# 1997 - 2002 Corvette: Service Bulletin: Door Rattle with Moderate to High Audio System Volume

**Number:** 01-08-64-009A

**Date:** 06-19-2002

**Model Year:** 1997-2002 Chevrolet Corvette

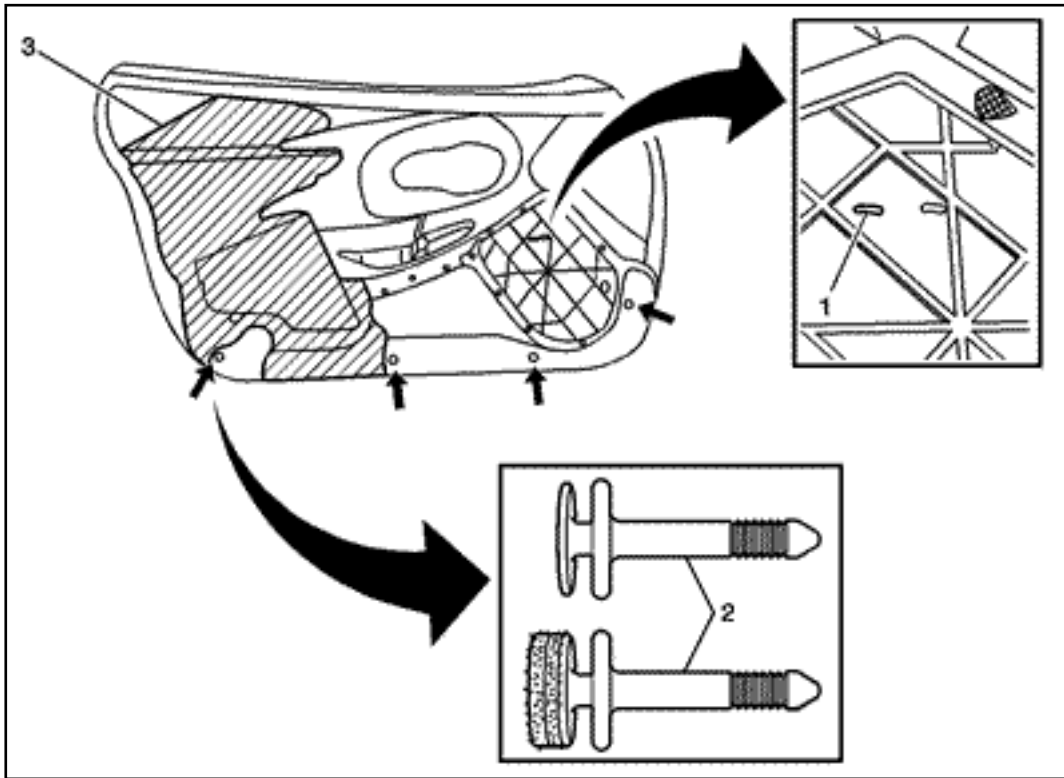
**Change implemented in 2002 VIN breakpoint 125078. Vehicles built prior to this breakpoint will require the following procedure.**

New speaker screen is made from a different material and Bose® emblem is provided due to risk of old emblem becoming damaged while removing.

1. Straighten the speaker grille tabs and remove the grille from the door panel.
2. Remove the Bose® emblem from the speaker grille and discard.
3. Remove the speaker screen from the grille and discard.
4. Install the new speaker screen to the grille.
5. Install the new Bose® emblem and carefully crimp the staples (1) to the speaker grille.
6. Insert the speaker grille tabs into the door panel slots and bend the tabs

to lock the grille in place.

7. Trim any extra loose door panel leather skin from around the speaker grille area on the back side of the door panel.
8. Repeat above steps for opposite side.

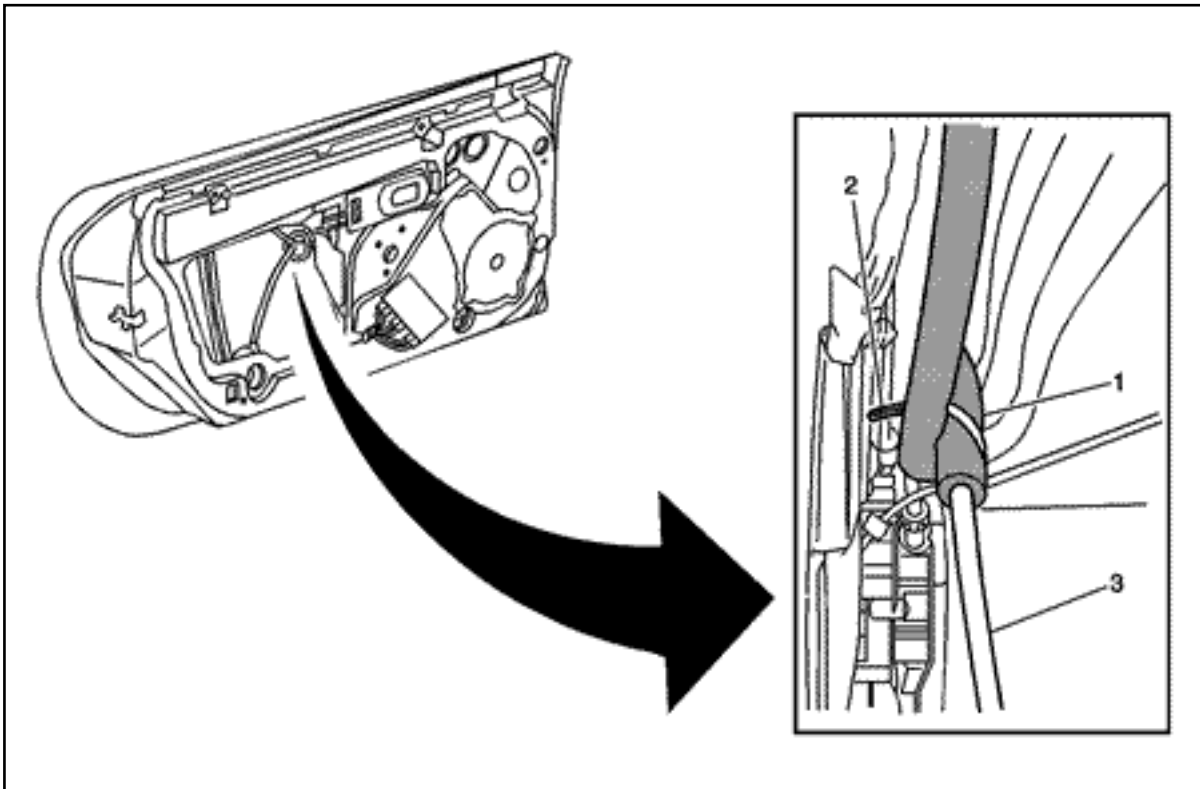
**Change implemented in 2001 VIN breakpoint 115500. Vehicles built prior to this breakpoint will require the following procedure.**

1. Remove the 4 lower door trim panel retainers (2) from both door panels.
2. Cut 16 dime sized coins from the fine side of Velcro®, 3M® P/N 051131-06481, or equivalent.
3. Install 2 Velcro® coins to each of the 8 door trim panel retainers (2).
4. Reinstall the door trim panel retainers (2) into the door trim panels.

**Change implemented in 2000 VIN breakpoint 110900. Vehicles built prior to this breakpoint will require the following procedure.**

1. Only perform the following procedure if the side impact styrofoam (3) is loose from the door panels.
2. Resecure the side impact foam (3) to the door trim panels using 3M® Urethane, P/N 051135-08690, or equivalent.

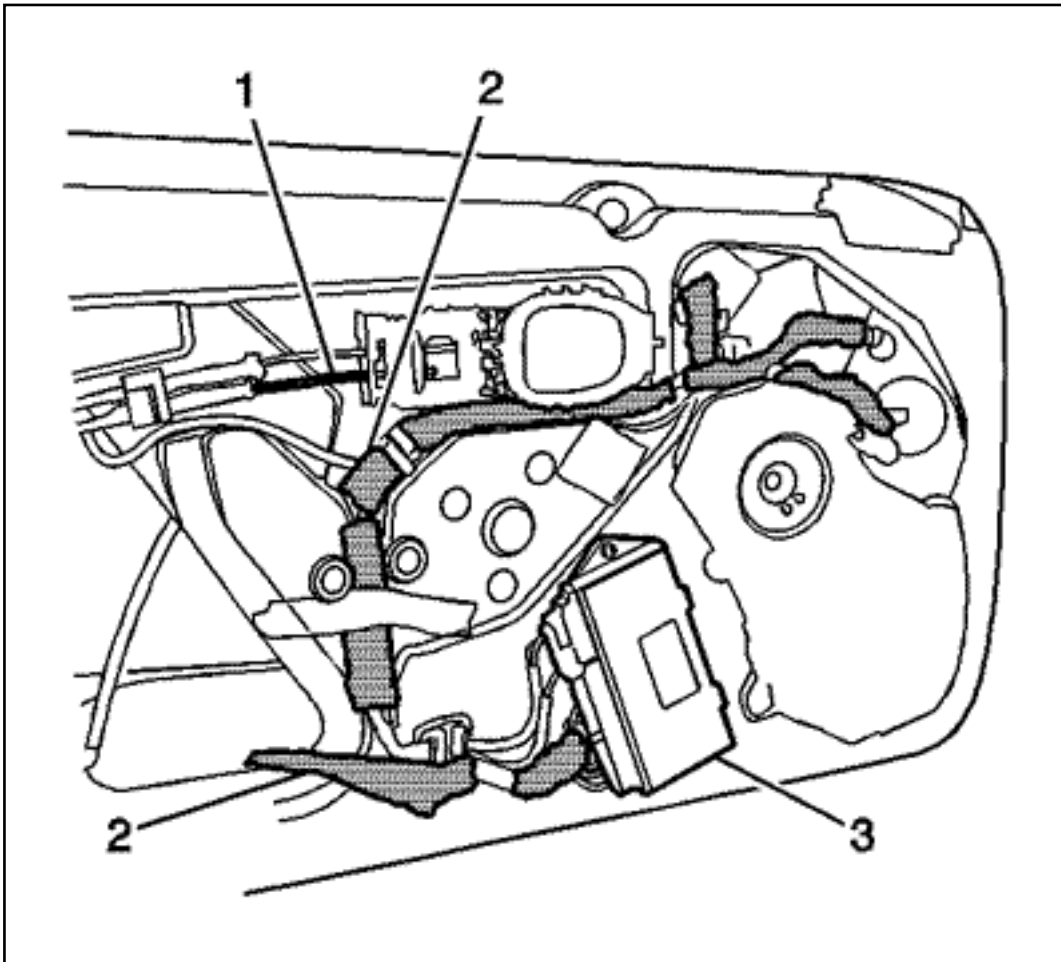
**Change implemented in 1999 VIN breakpoint 133100. Vehicles built prior to this breakpoint will require the following procedure.**

1. Remove the water deflector.

**Do not damage the push-in retainer/tie straps (2). They are to be reused.**

2. Remove the push-in retainer/tie straps (2) that retain the window regulator cables (3) to the inner door panels.
3. Reposition the push-in retainer/tie straps (2) out of the way.
4. Add 122 mm (5 in) of 3M® Open Cell Interior Foam Tape (1), P/N 051131-62385, or equivalent, to the window regulator cables (3) where they contact each other and the inner door panels.

5. Reinstall the push-in retainer/tie straps (2).
6. Reinstall the water deflector.

**Change implemented in 1999 VIN breakpoint 130801. Vehicles built prior to this breakpoint will require the following procedure.**

1. Remove the inside door handle. Refer to Door Handle Replacement - Inside in the Service Manual.
2. Remove the manual lock rod (1), lower of the two lock rods, from the anti-rattle retainer.
3. Remove the manual lock rod (1) from the door lock assembly by

twisting the lock rod out of the retainer.

4. Install new manual lock rods (1), P/N 10232183 (left side) and P/N 10232184 (right side), into the door lock assembly.
5. Install the manual lock rods (1) into the inside door handle and the anti-rattle retainer.
6. Reinstall the inner handle. Refer to Door Handle Replacement - Inside in the Service Manual.
7. Reinstall the water deflector.

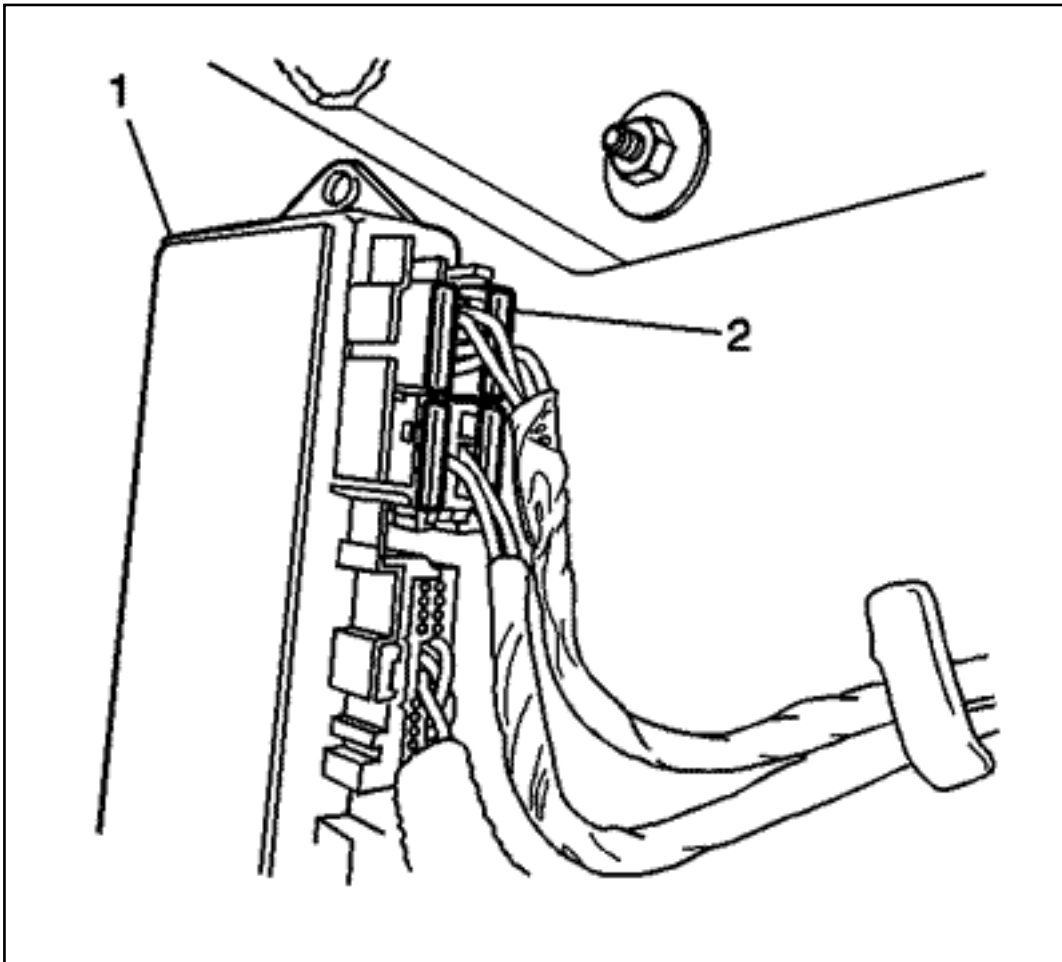
**Change implemented in 2000 VIN breakpoint 101578. Vehicles built prior to this breakpoint will require the following procedure.**

1. Remove the wire harness (2) from its retainers.
2. Insulate the wiring harness and in-line connectors (2) where the wiring harness and the in-line connectors (2) contact the door with 3M® Open Cell Interior Foam Tape (2), P/N 051131-62385, or equivalent. It is best to insulate the entire wiring harness (2).
3. Insulate the right door speaker connector with P/N 12378189.

**Change implemented in 2000 VIN breakpoint 123000. Vehicles built prior to this breakpoint will require the following procedure.**

1. Remove the screws attaching the door control modules (3).
2. Add felt, P/N 12378189, to the backside of the door control modules (3) where it contacts the inner door panels.
3. Position the door control modules (3) to the doors.
4. Install the screws attaching the modules (3). **Tighten**

Tighten the door control modules (3) attaching screws to 3 N·m (27 lb in).

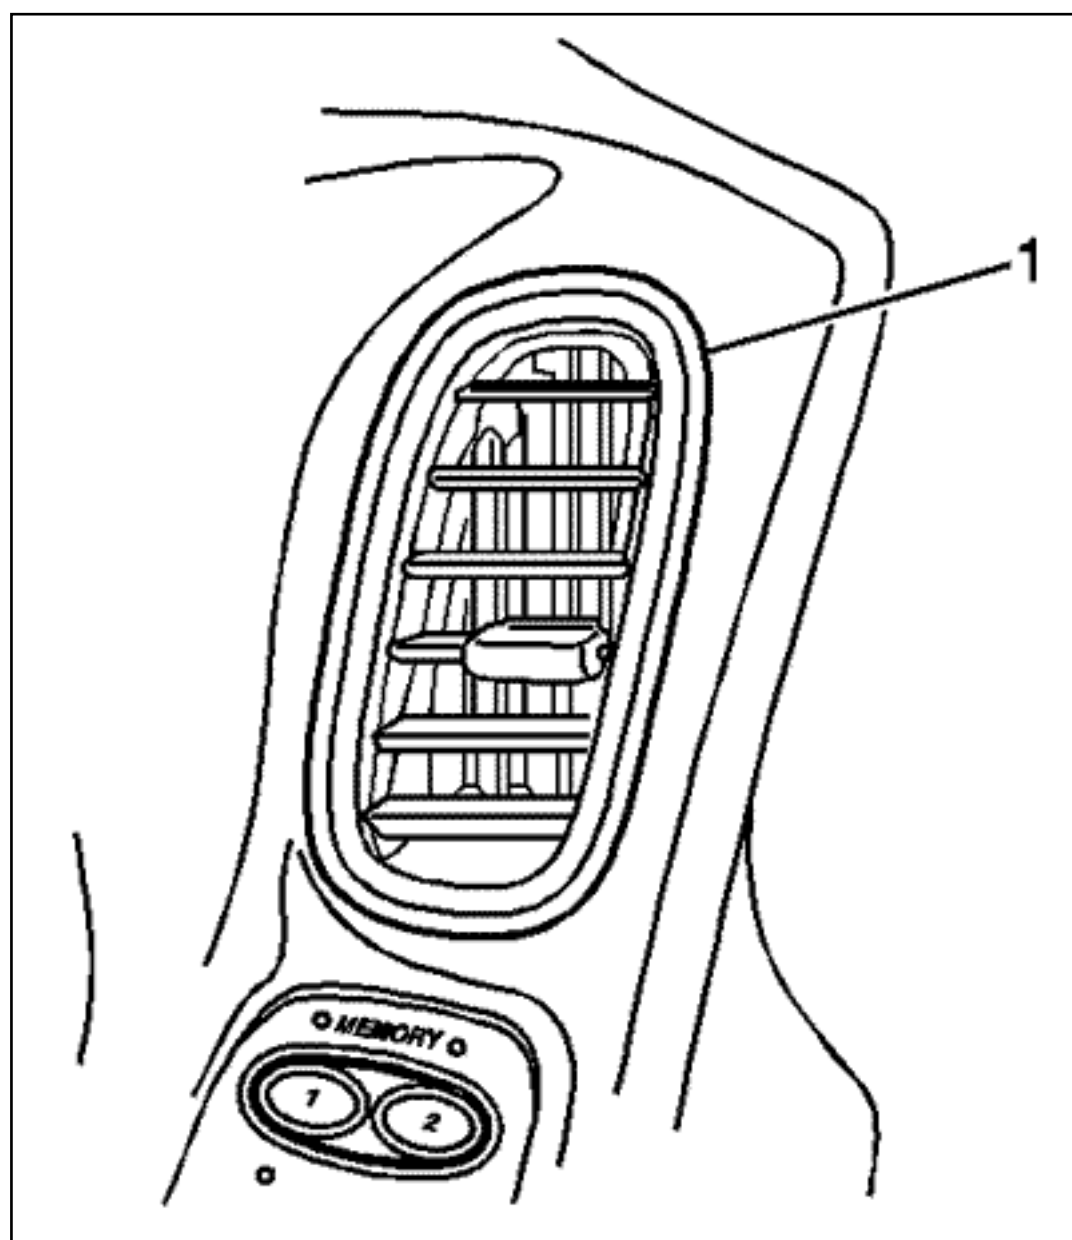
**Change implemented in 2000 VIN breakpoint 120397. Vehicles built prior to this breakpoint will require the following procedure.**

Add a small piece of duct tape, 3M® P/N 051131-06969, or equivalent, to the door control modules (1) terminal positive assurance (TPA)'s (2). They are grey in color and there are a total of 4 TPA's (2) per door. If the TPA's (2) are blue, they are the new design and do not need to be taped.

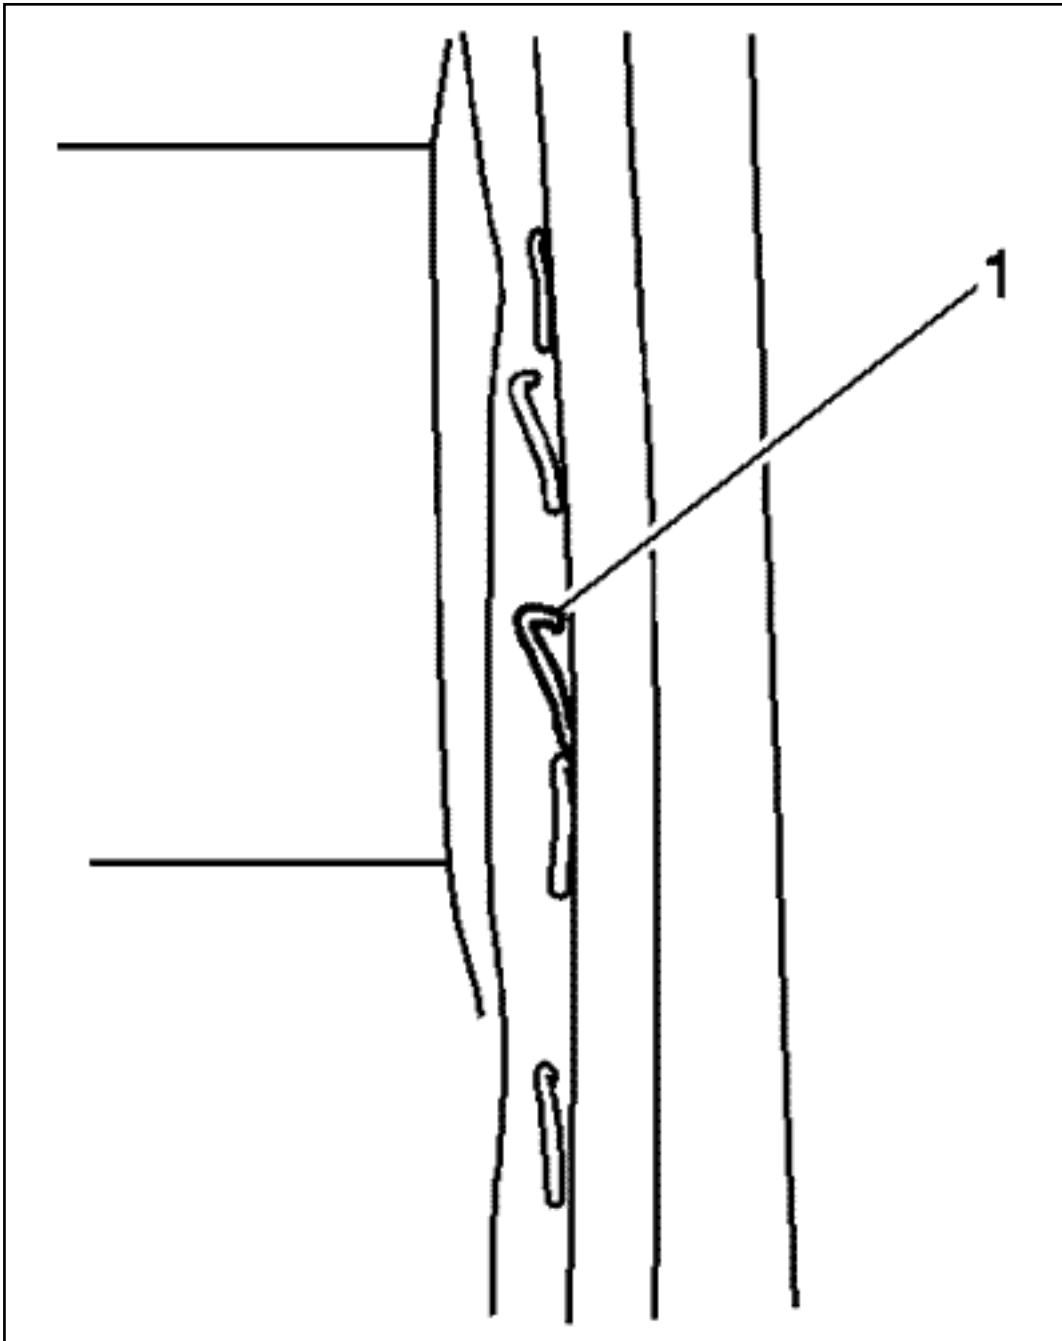
Replace the driver's door HVAC deflector (1), P/N 10406518, if the vanes of the deflector (1) are loose and vibrate. Refer to Door Trim Panel Air Duct and Deflector Replacement in the Service Manual.

Recrimp or remove any loose staples (1) that retain the door panel leather skin to the door trim panel on the outside perimeter of the door trim panels.
